SECTION 009113 – ADDENDA ONE

- A. Project Name: < **Maine Criminal Justice Academy | Phase One Façade Restoration**
- B. Owner: < **Maine Criminal Justice Academy** >.
- C. Owner Project Number: < TBA >.
- D. Architect: < **LeMessurier Consultants** >.
- E. Architect Project Number: < **21.0240.001** >.
- F. Date of Addendum: < **September 28, 2022** >.

Schematic photo-map of MCJA Campus (see Page 8 for map)

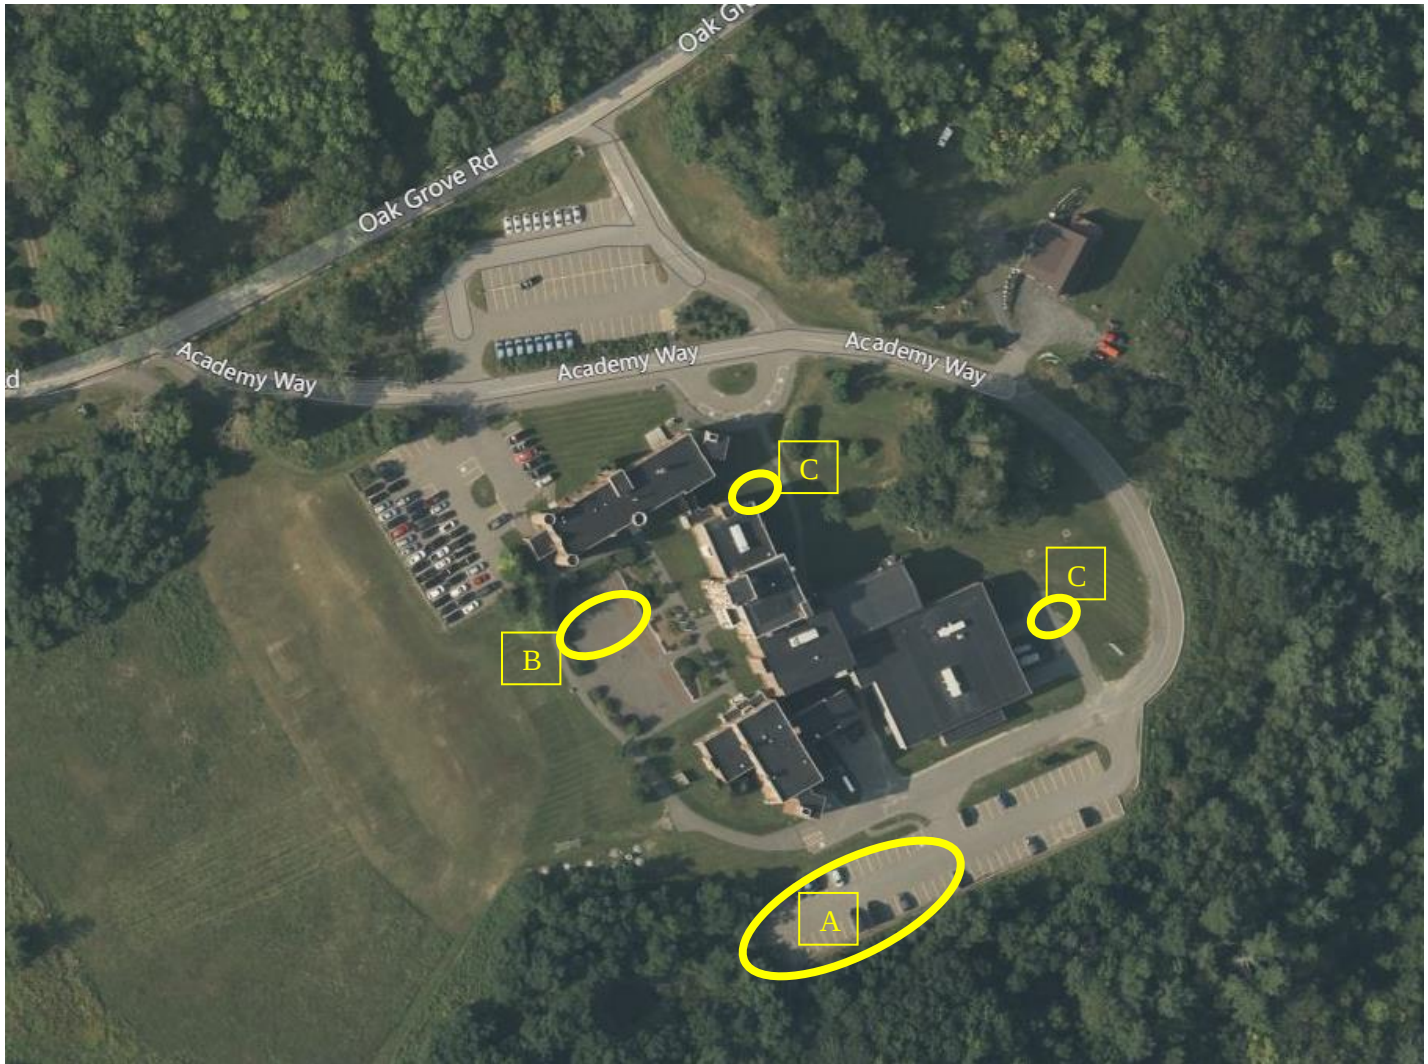
12. QUESTION; A lot of conversation has gone around related to electrical and water requirements for this project. Water will be needed within a 100' of where any of the work is occurring and electrical will vary in each area depending on the contractor. But several at least 3, 30- amp circuits should be less that 100 feet for any area that is being worked on. In some cases, a 220 circuit may be required. If the contractors are required to carry the cost for connecting to the permanent power to get to each area, then we need to know what is available where. Please advise

20. QUESTION: Will there be a spot on site to keep dumpster for daily clean up?

Response: refer to Schematic photo map and narrative at end of this section

Response: refer to Schematic photo map and narrative at end of this section

Basis of design for providing temporary services and areas is based on limited contractor information at time of bidding. As result, below is approximate with exception to defined areas A, B, C and contractor parking and deliveries, subject to coordination with owner and or for short durations relocation for use.

1. Power is accessible to most sides of the building via windows, or other. Additionally, Owner to provide temporary power to areas A,B, and C subject to limitations as contractor needs are not accurately known.

2. Water is accessible to all 4 major sides of the building configuration, additional water access to be provided, but limited to availability and contractors equipment requirements.

3. Area A
 - a. Deliveries
 - b. Temp toilet “port-a-potties”
 - c. Storage /staging / prep area
 - d. Construction trailer
 - i. Signage at entry from academy directed construction related work to area A and construction trailer

- e. Contractor Parking
4. Area B and C limited based on access from side walk or rear parking lot access, coordinate with owner
 - a. Storage /staging/prep area

5. Other areas adjacent to the building during construction are as needed and to be returned to pre-construction state
